A7. POST-APPLICATION DISCUSSION

COMMENTS BY THE PRIMROSE HILL CONSERVATION AREA ADVISORY COMMITTEE

Primrose Hill Primary School Princess Road NW1 8JL Listed Building PRE-APP

LB PLANNING AND CONSERVATION

BUGGY STORE
SECTION
AS PROPOSED

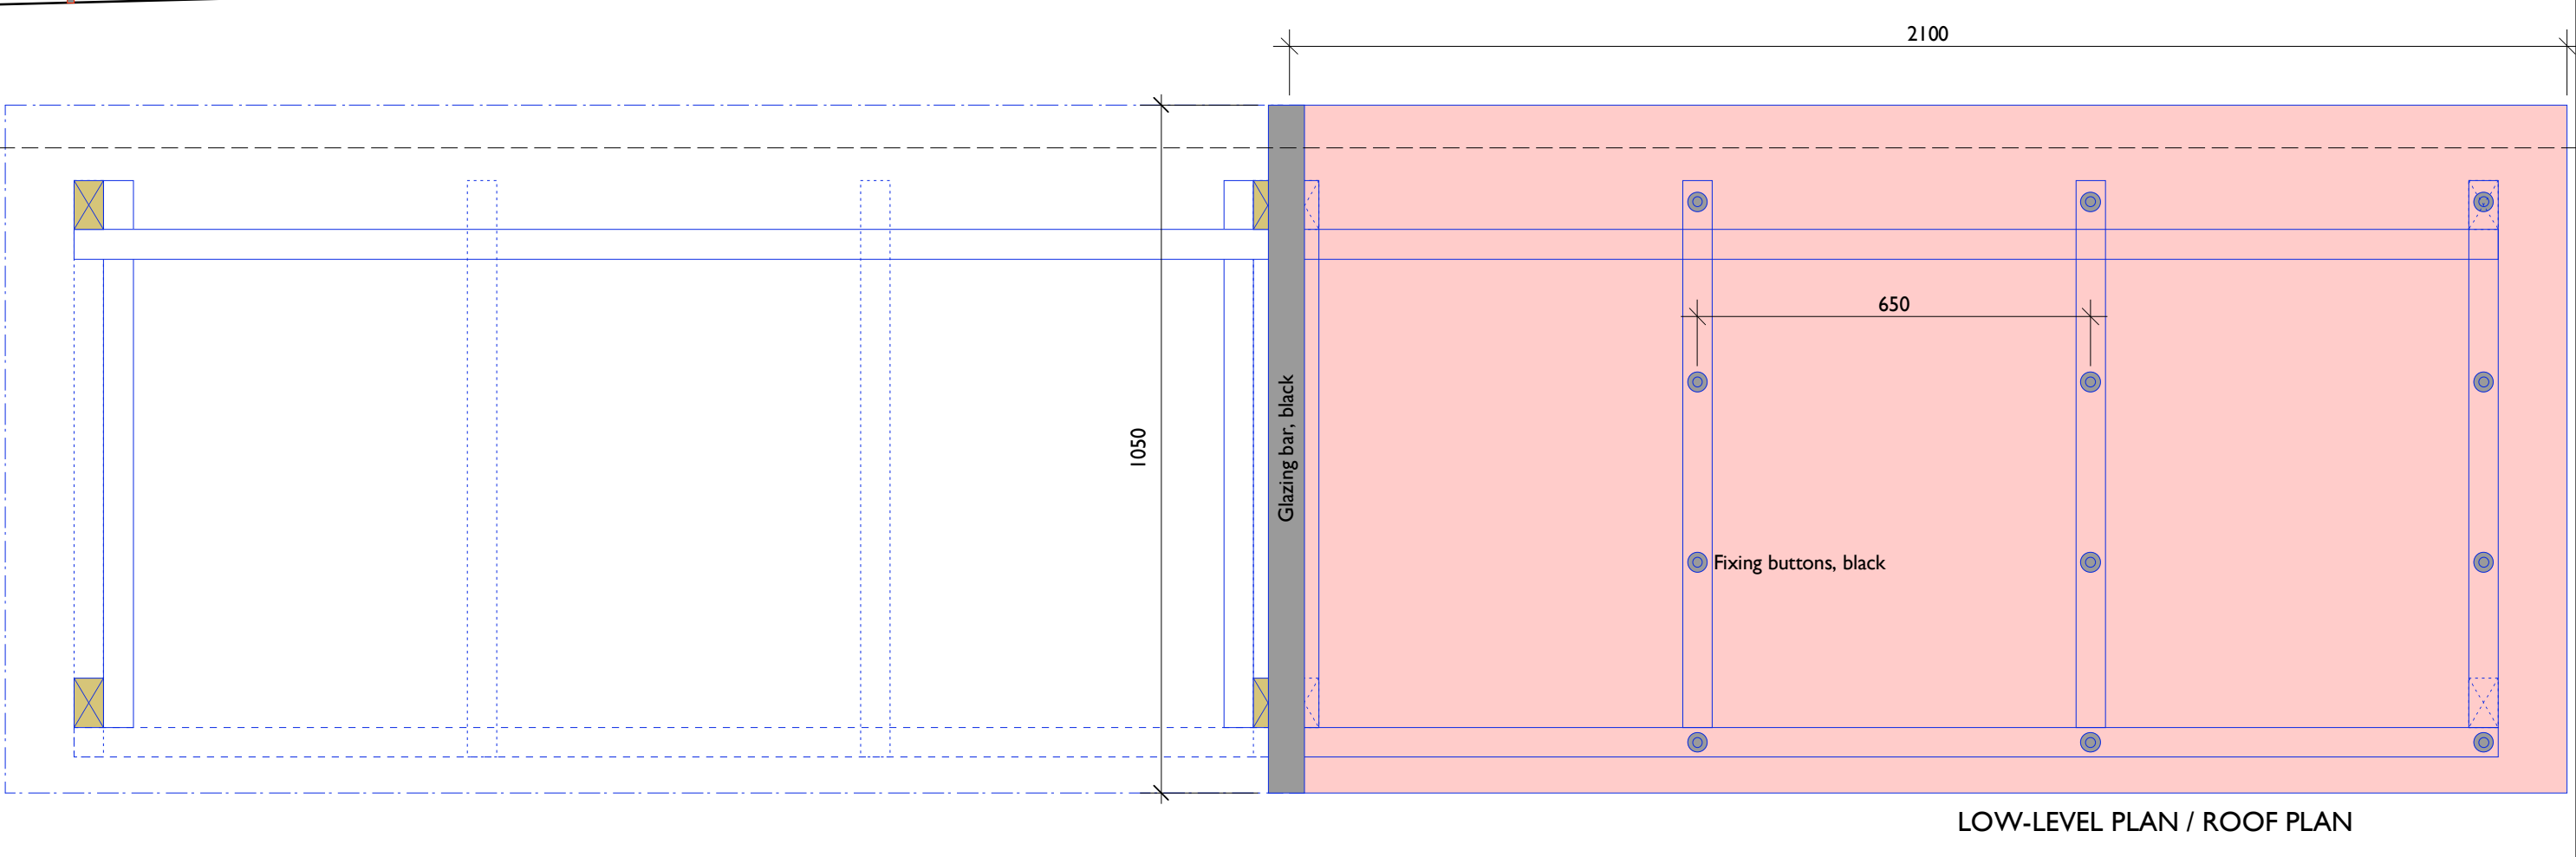
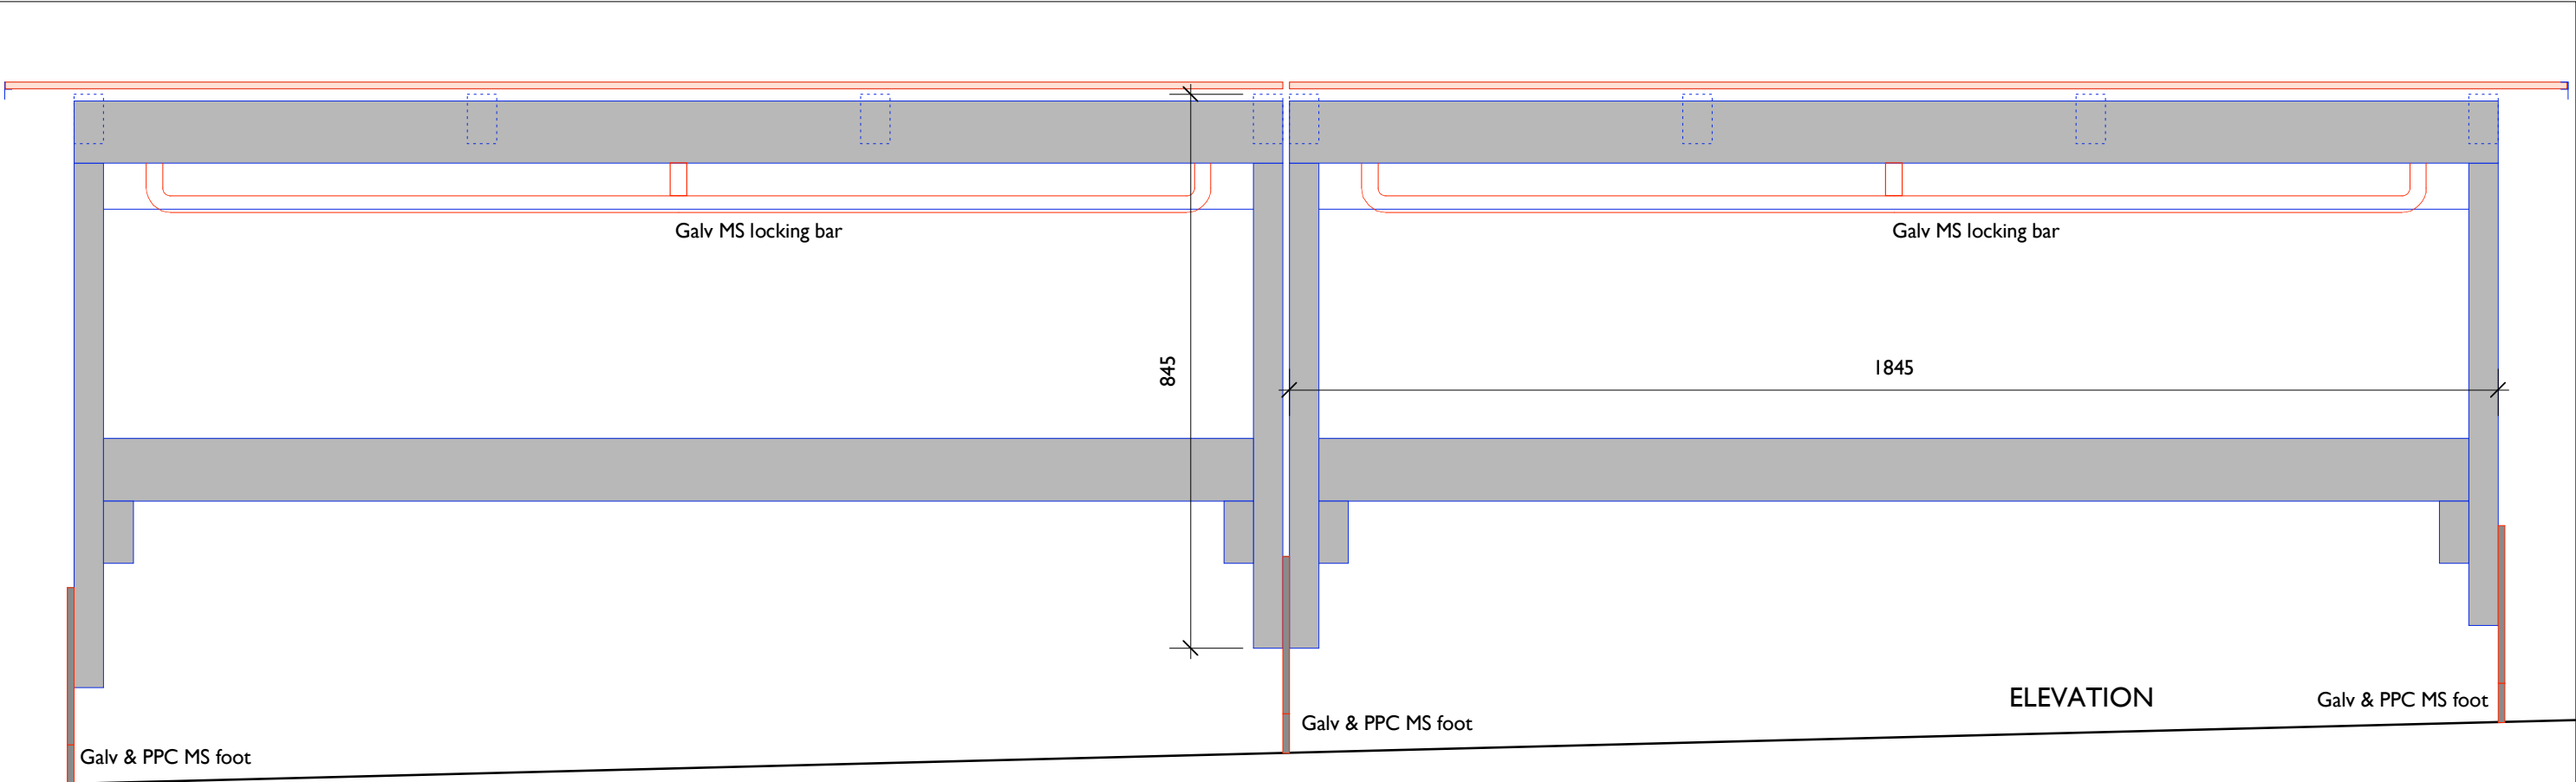
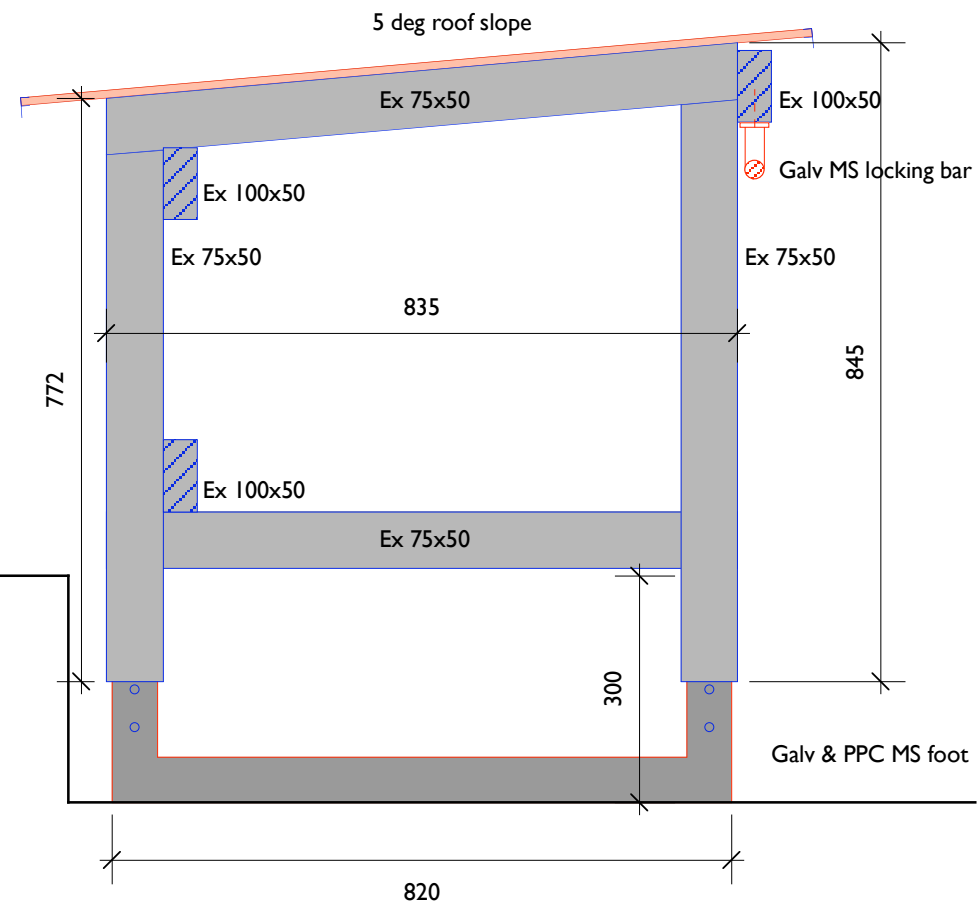
- 5. Further detail of the proposed buggy store.

16. More detail on the Buggy Store at the front of the Caretaker’s House to be provided.

Response: Further detail on the Buggy Store at the front of the Caretaker’s House is attached below: PRPS PR 525_G and PRPS PR526_G.
